City of Canada Bay Council

ACCESSIBILITY ACTION PLAN FOR PARKS, OPEN SPACE AND FACILITIES

Adopted by Council 20 July 2004

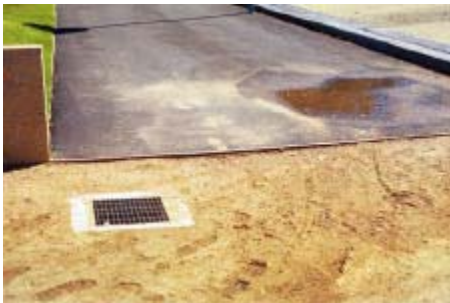
Pedestrian Pathways	1.17.2	Install a handrail 865-1000mm high, or kerb guard 150mm high along water side of footpath. Additionally, tactile ground surface indicators should be used to warn of the water hazard.	2006/2008	Medium
